Temperature sensors on APAs

Introduction

- Few problems have been observed in RTD kits sent to Daresbury and Chicago. Many apologies to both for the inconveniences
- Kits not yet installed have been returned to IFIC and are being carefully inspected and repaired
- The path forward
 - 1.Characterise observed problems
 - 2.Repair existing kits
 - 3.Changes in production procedures for new kits
 - 4.Changes in QA/QC procedures for repaired/new kits
- These items will be covered in this talk

Problem 3.b: Epoxy quality

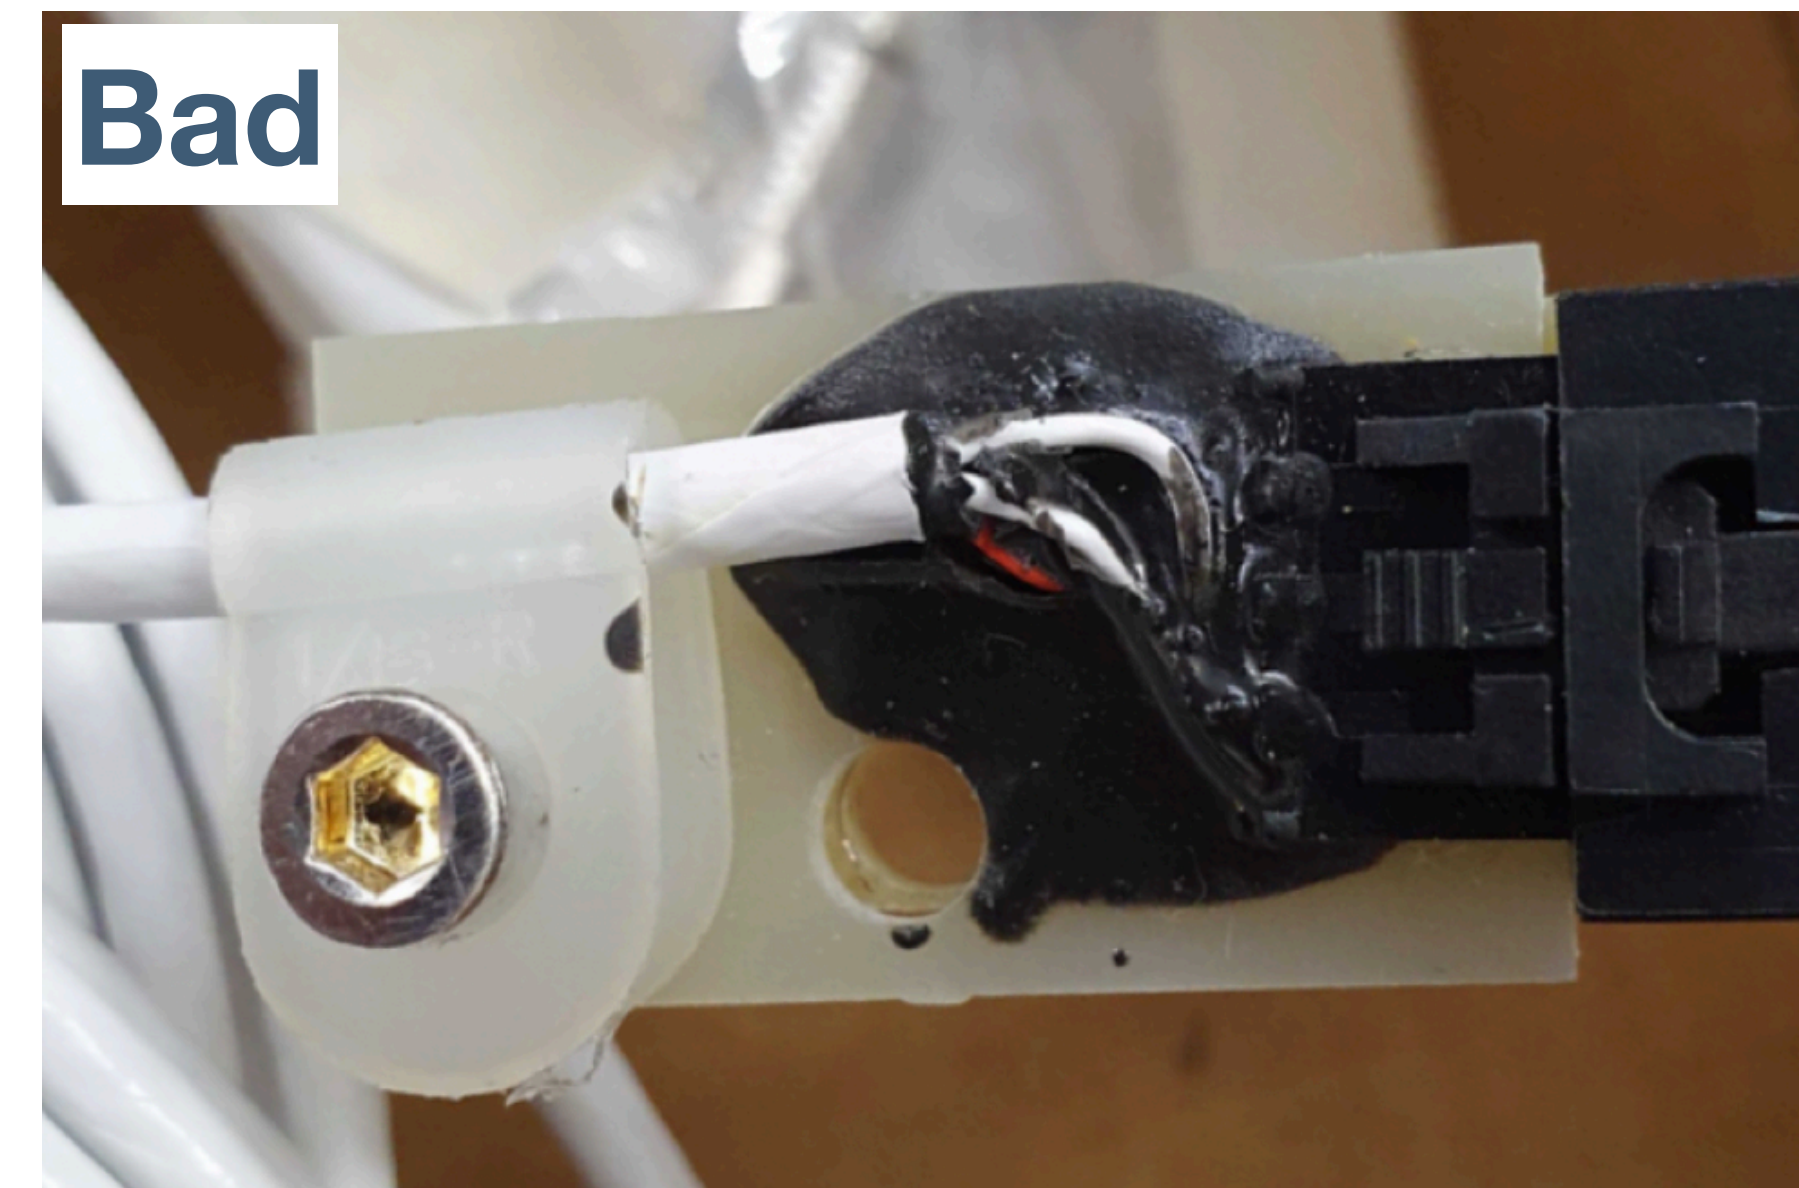
- The four little cables not completely covered by epoxy
- **Repair:** add more epoxy
- **Changes in production:** when applying epoxy make sure it covers cables
- **Changes in QA/QC:** make sure epoxy covers cables

Problem 3.c: Epoxy quality

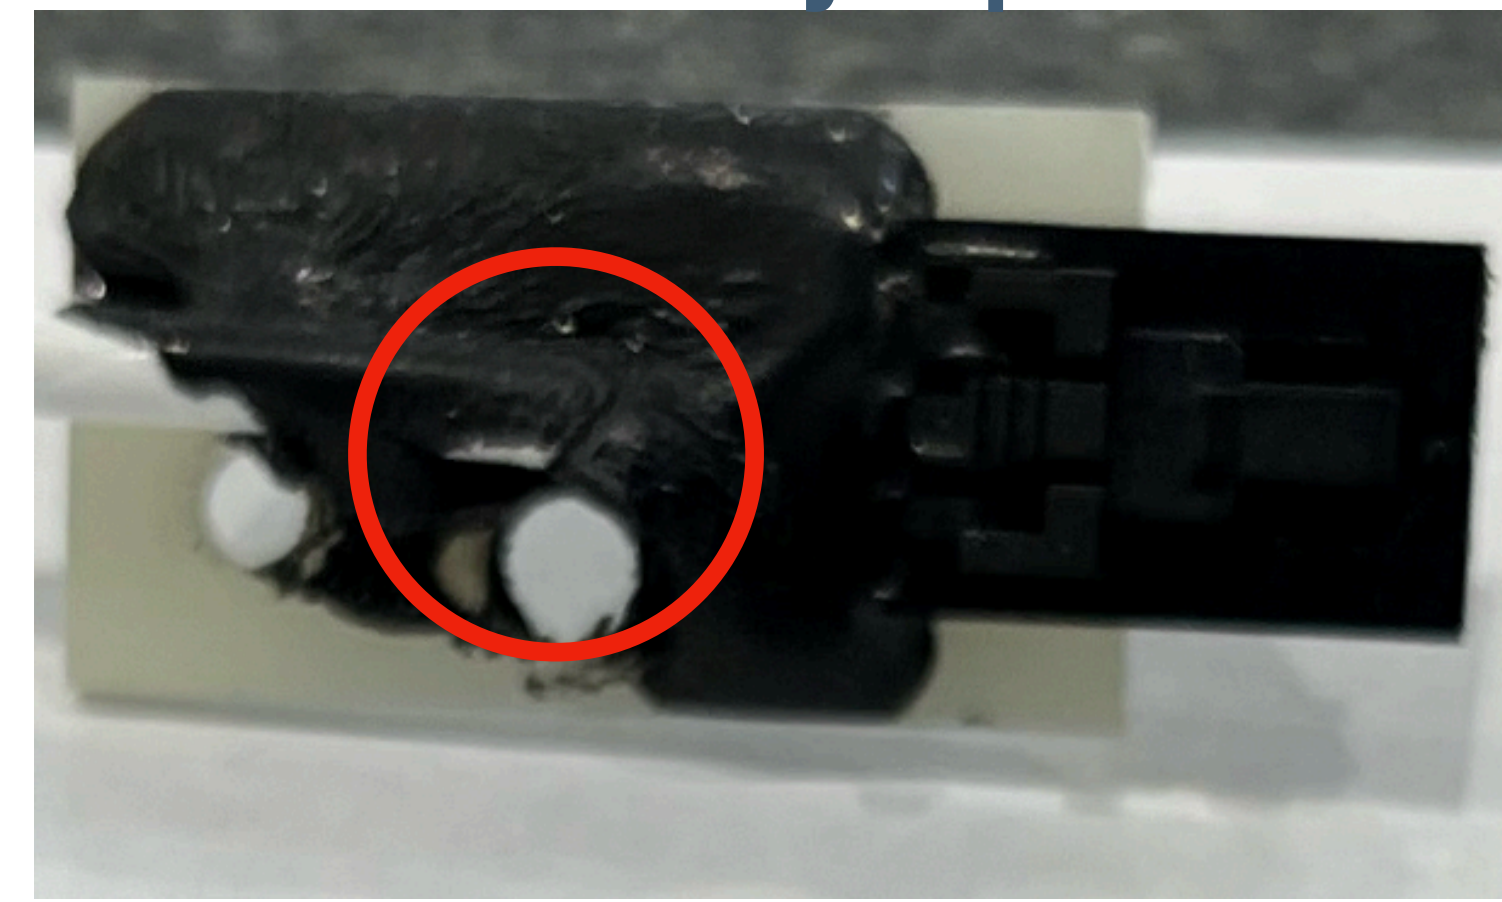
- Epoxy prevents housing the M4 screw head
- **Repair:** remove extra epoxy with a drilling machine
- **Changes in production:** none, a temporary bolt is used when adding epoxy
- **Changes in QA/QC:** mount entire kit

Cable is too close, cannot be easily repaired

Problem 3.d: Epoxy quality

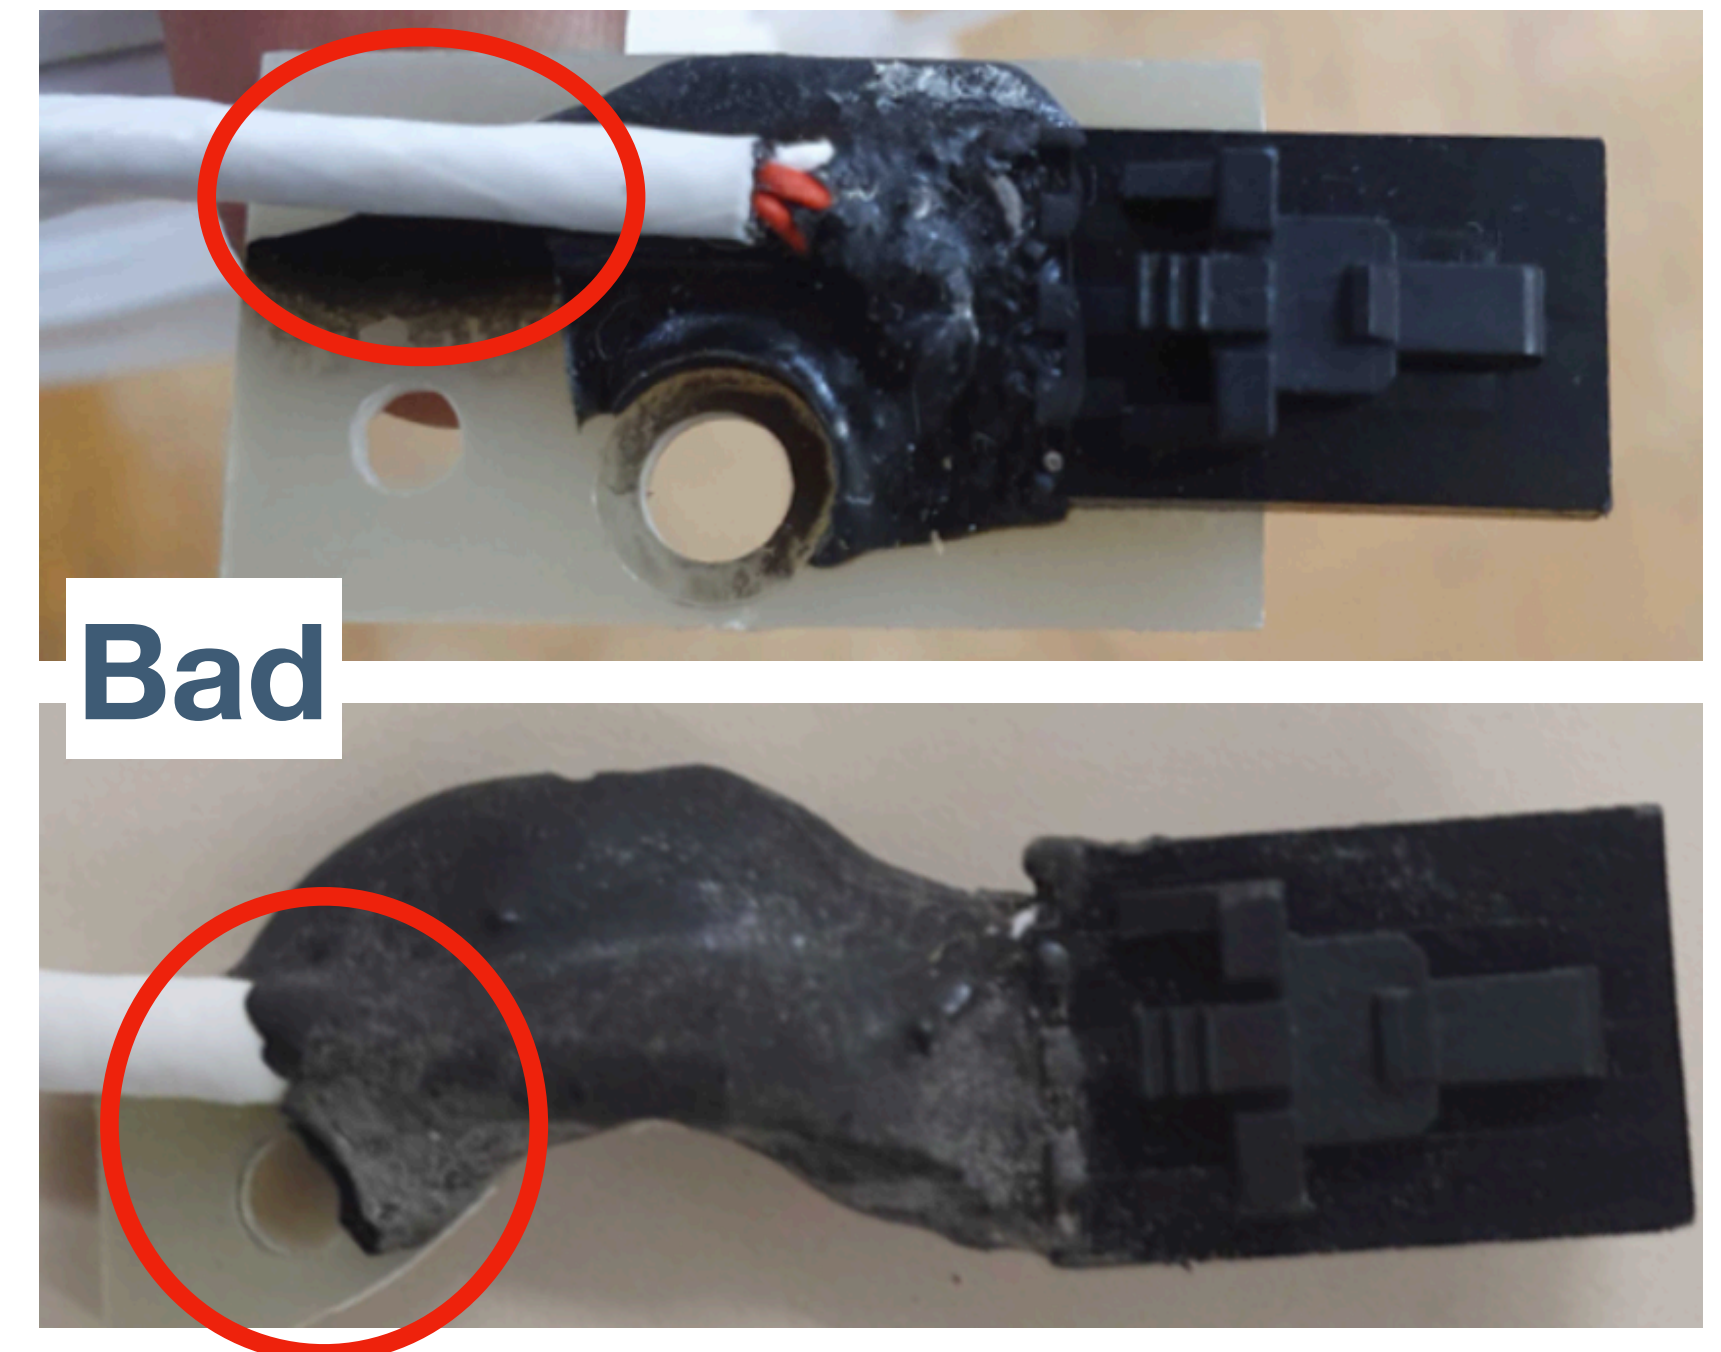
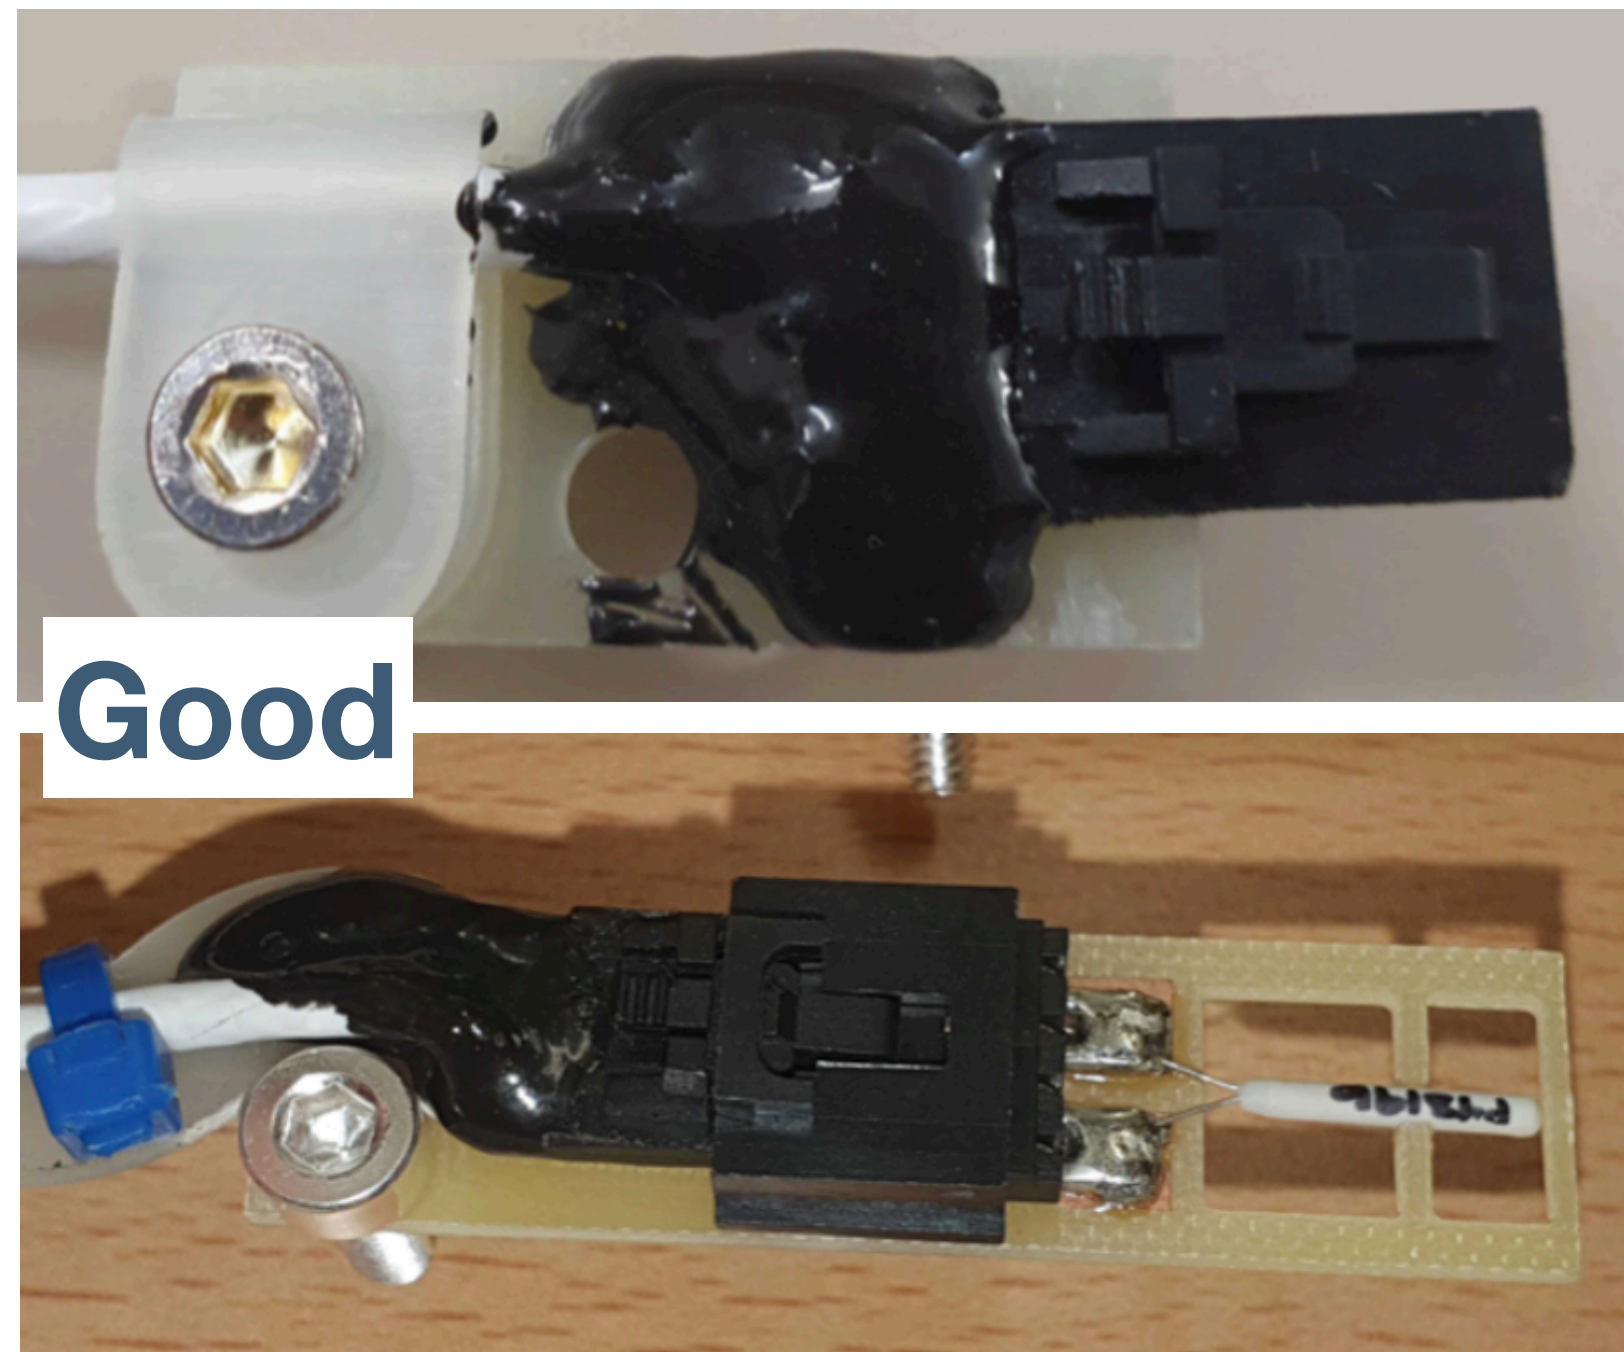
- Epoxy prevents adding the cable clamp/tie
- **Repair:** remove extra epoxy when possible
- **Changes in production:** add cable tie/clamp before epoxying
- **Changes in QA/QC:** make sure cable tie/clamp is present before
